AUSTRALIAN NOTICES TO MARINERS

Notices 254 - 299

Published fortnightly by the Australian Hydrographic Service

Edition No 6 dated 30 March 2007

Page 180, KOREA, SOUTH, TELEMEDICAL MARITIME ADVICE SERVICES (TMAS).

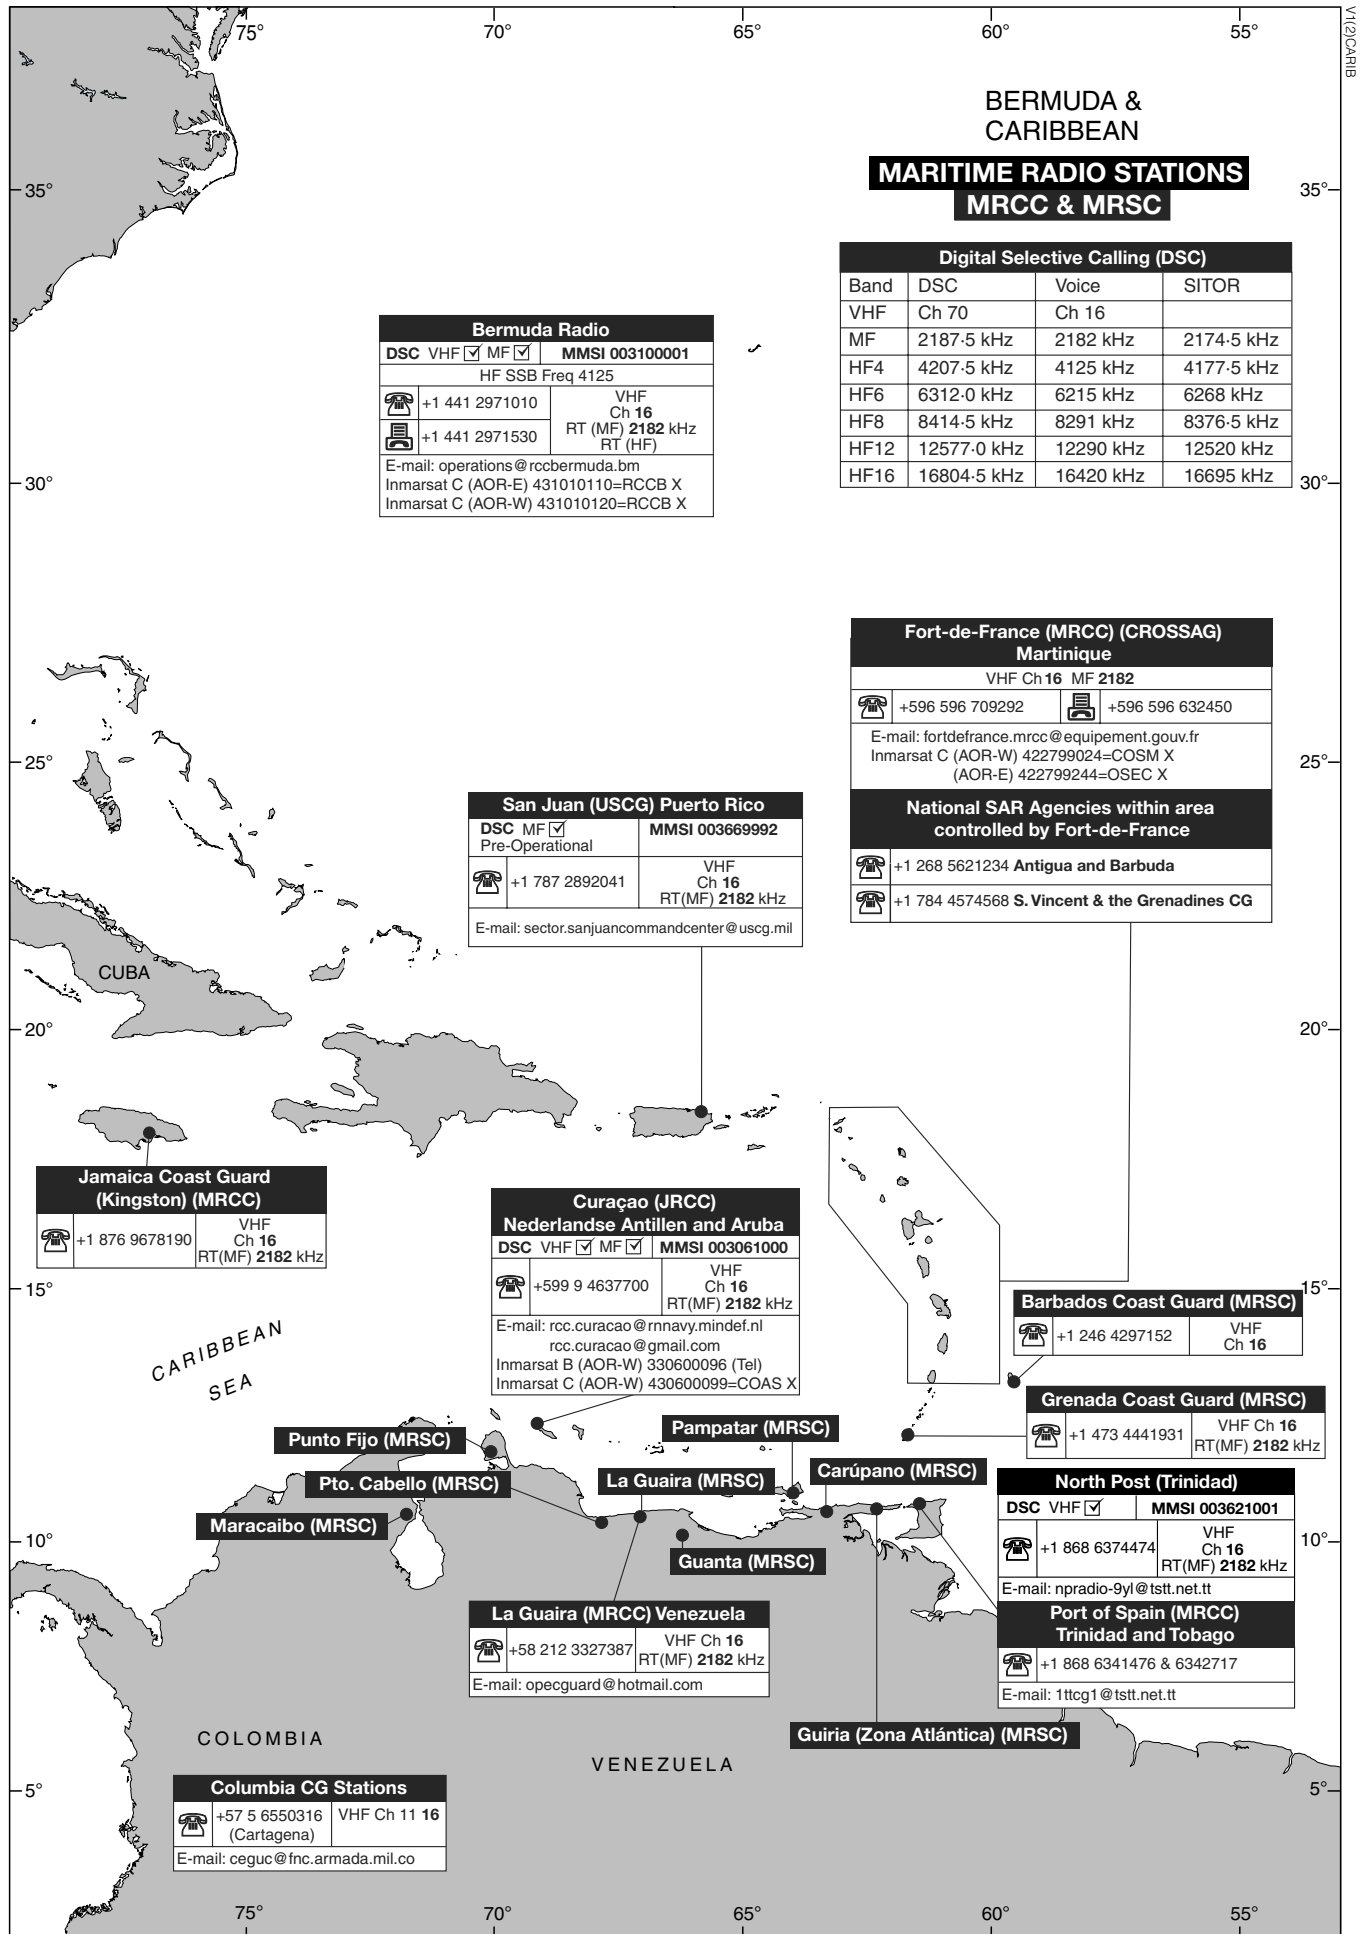
Delete and replace by:

TELEMEDICAL MARITIME ADVICE SERVICES (TMAS)			
Usual name of centre		Korea coastguard	
		Diagram page 181	
Communications DSC A1 A2 & A3/4	MRCC:		Maritime Radio Station:
	Cheju (Jeju) MRCC	MMSI 004401005	Inch'ŏn (Incheon) Radio MMSI 004400001
	Inch'ŏn (Incheon) MRCC	MMSI 004401001	Kangnŭng Radio MMSI 004400601
	Mokp'o MRCC	MMSI 004401003	Mokp'o Radio MMSI 004400301
	Pusan (Busan) MRCC	MMSI 004401004	Pusan (Busan) Radio MMSI 004400101
	Tonghae (Donghae) MRCC	MMSI 004401002	Seoul Radio MMSI 004400002
 Korea MRCC: +82 32 8352352		 Korea MRCC: +82 32 8589595	
TELEX +801 24920 (ROKNMPA K24920)		E-MAIL: mrcckorea@kcg.go.kr	
MRCC or JRCC		Associated MRSC	
Cheju (Jeju) MRCC			
Inch'ŏn (Incheon) MRCC		Gunsan MRSC & Taeon MRSC	
Mokp'o MRCC		Wando MRSC & Yeosu MRSC	
Pusan (Busan) MRCC		T'ongyŏng (Tongyeong) MRSC & Ulsan MRSC	
Tonghae (Donghae) MRCC		P'ohang MRSC & Sokch'o MRSC	
Consultation Languages		English. Interpreters may be arranged for other languages.

Remarks		Contact any MRCC/MRSC or port control centre and Telemedical Maritime advice will be provided from a regional public hospital. Attention is drawn to the International Code of Signals, Medical Section.

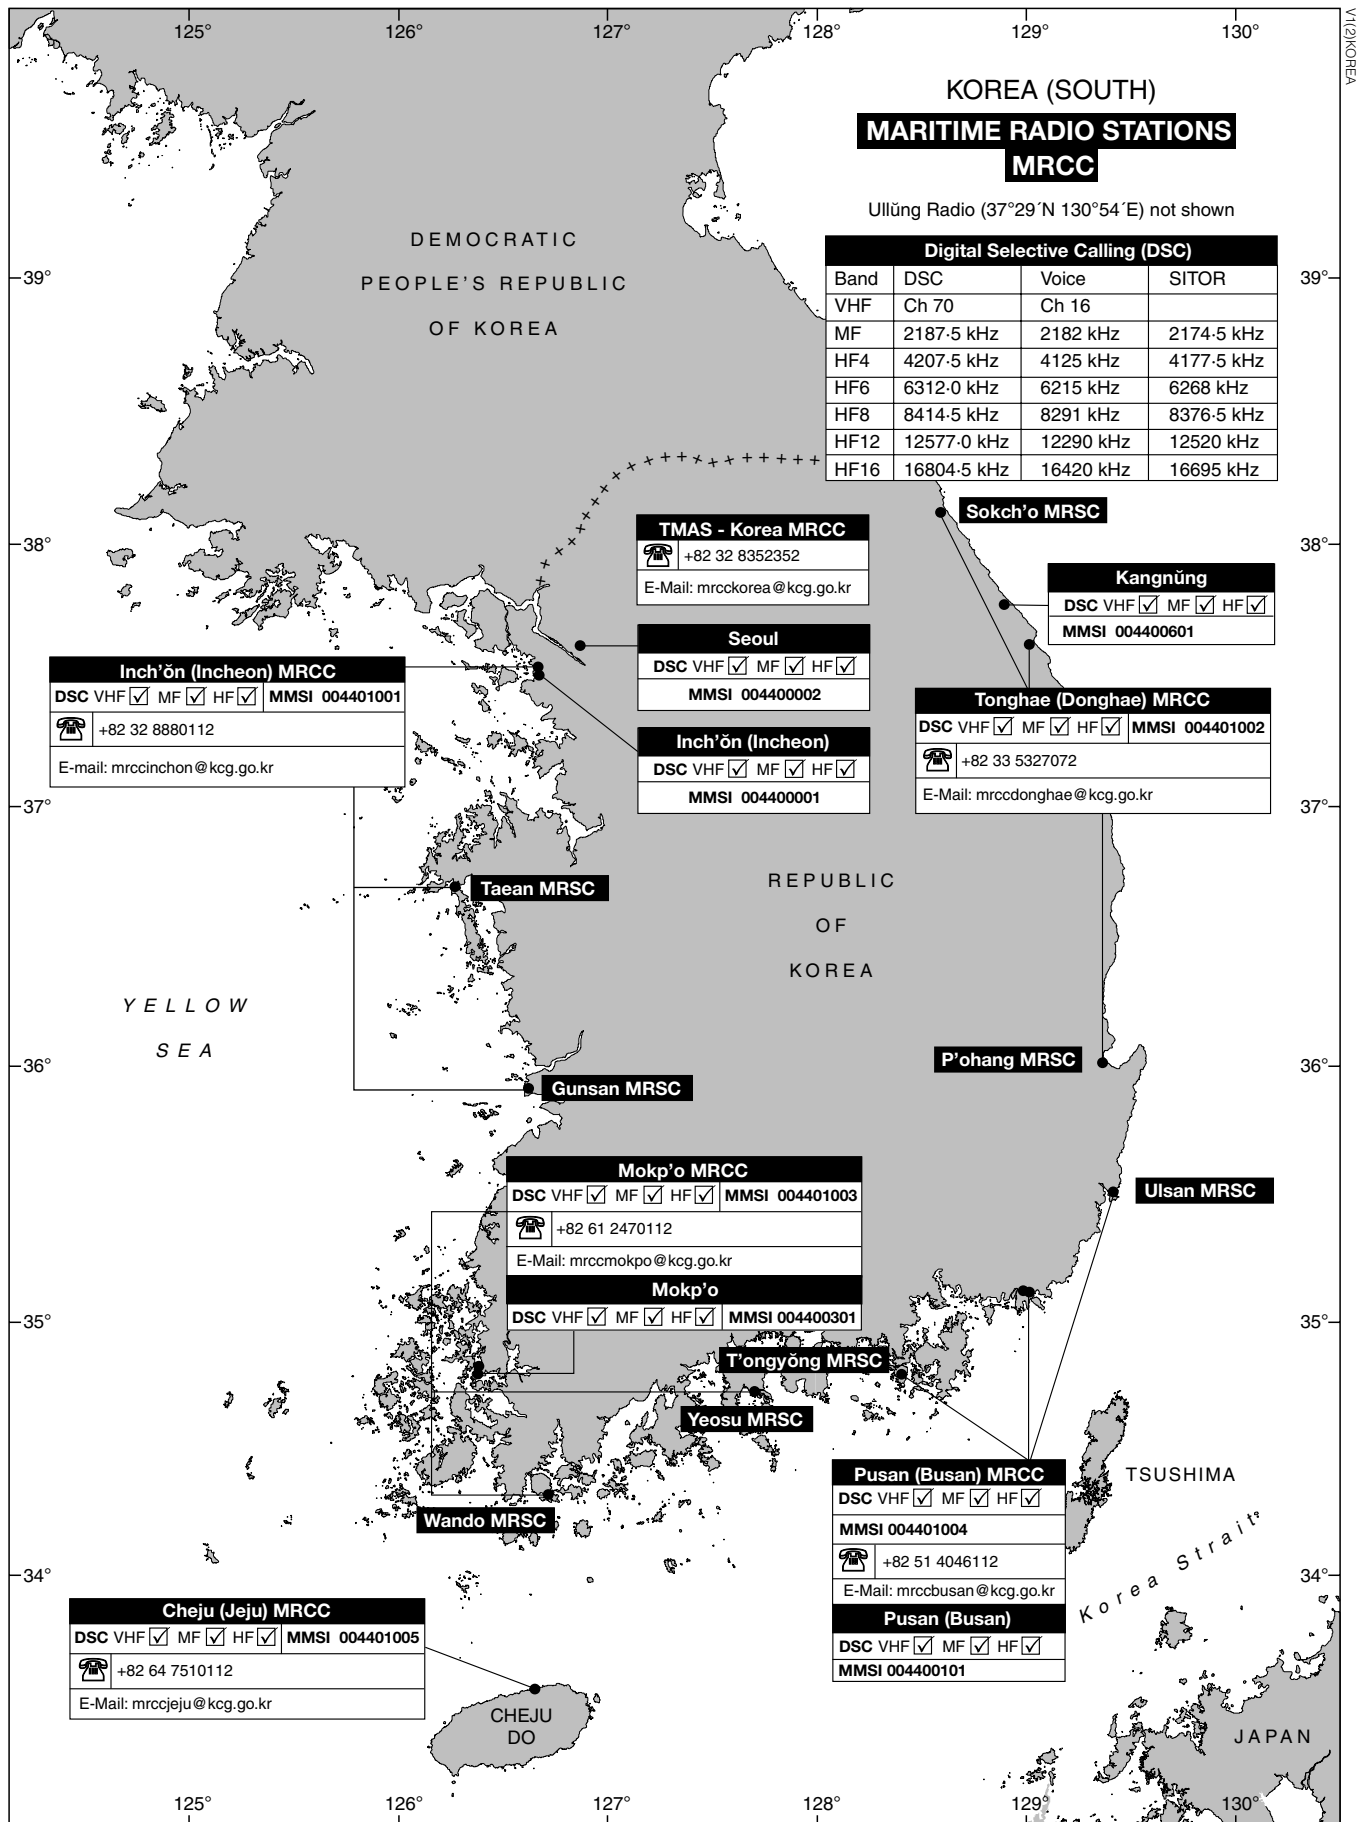
Delete and replace by:

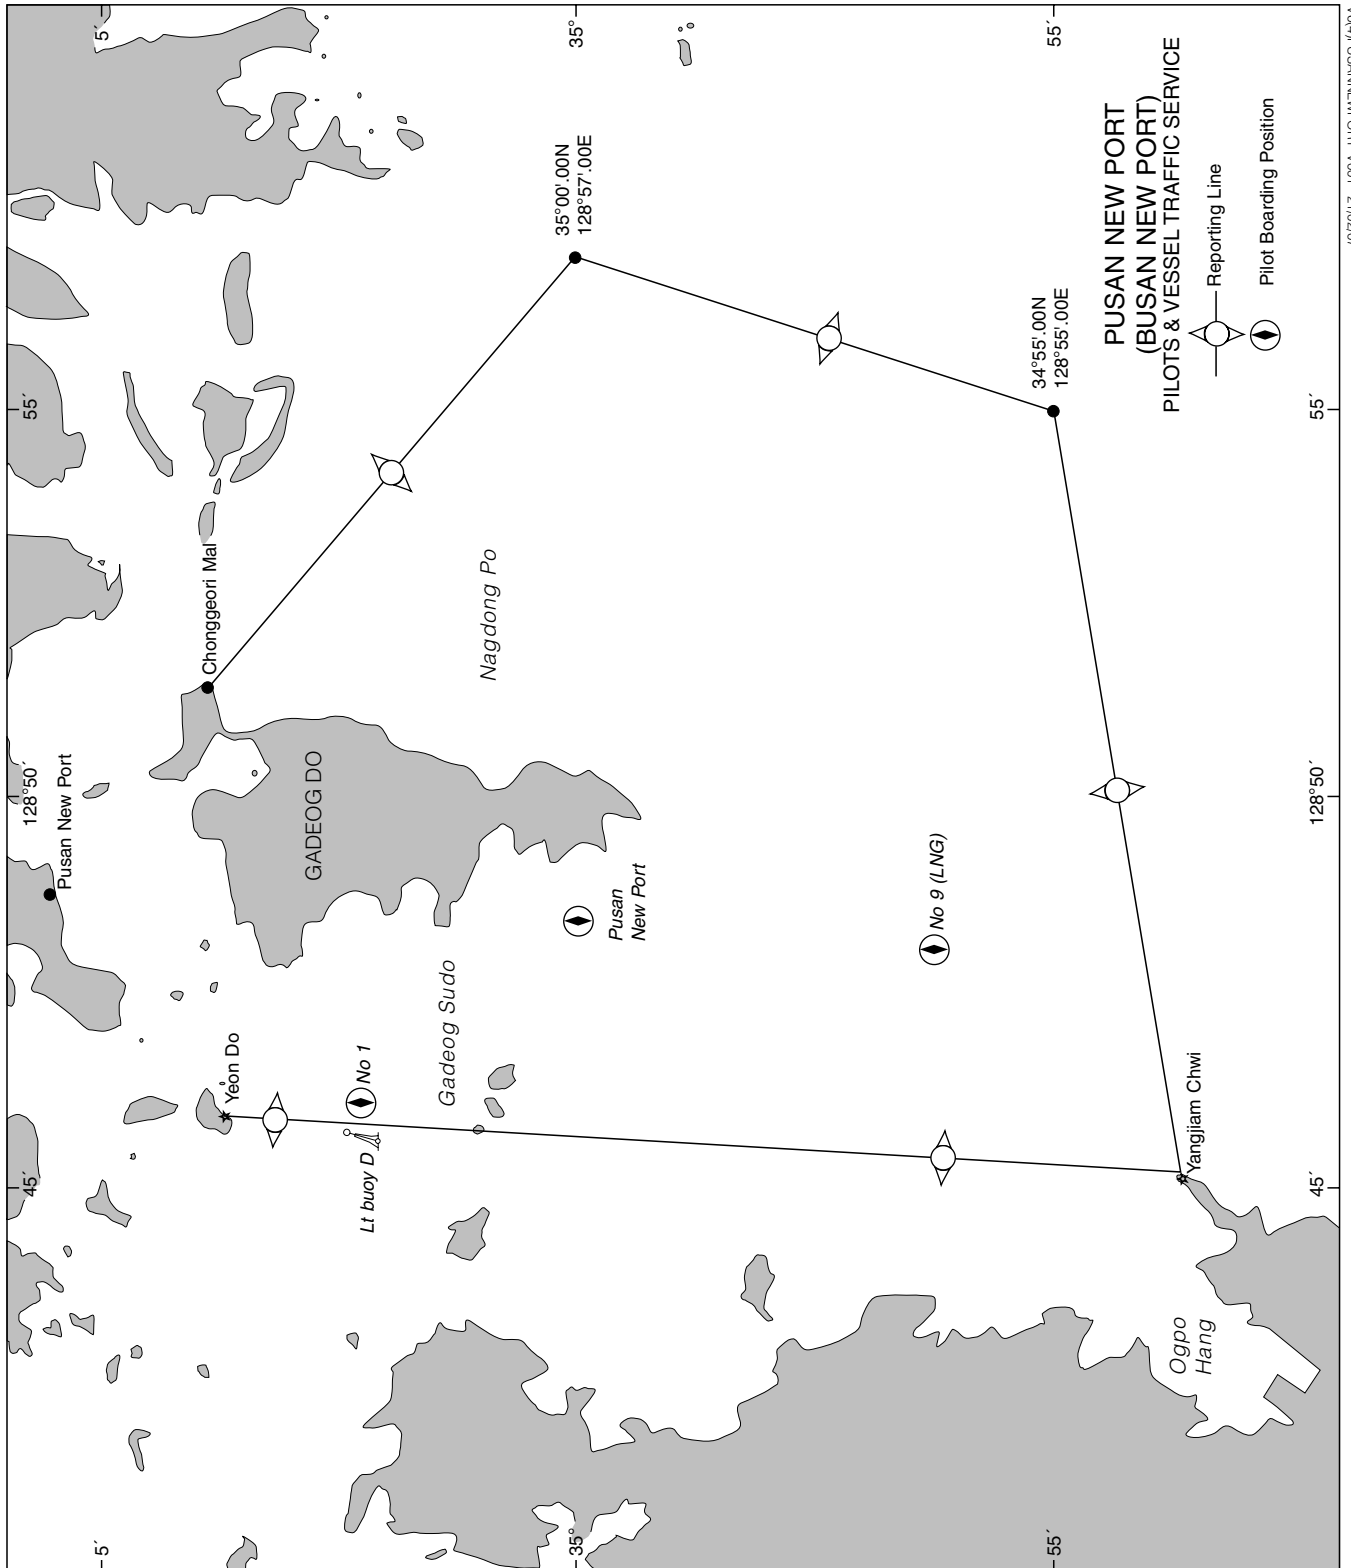
- (iii) Next port of call
- (4) Vessels must maintain a continuous listening watch on VHF Ch 10.
- (5) Vessels must change VHF Channel from Pusan New Port Service (VHF Ch 10) to Masan Port Service (VHF Ch 14) when passing "D" Lt buoy.

- (6) Vessels are recommended to report any abnormalities of aids to navigation including changes to their position.
- (7) Permission must be obtained from Pusan New Port Service before dropping anchor in the VTS area.
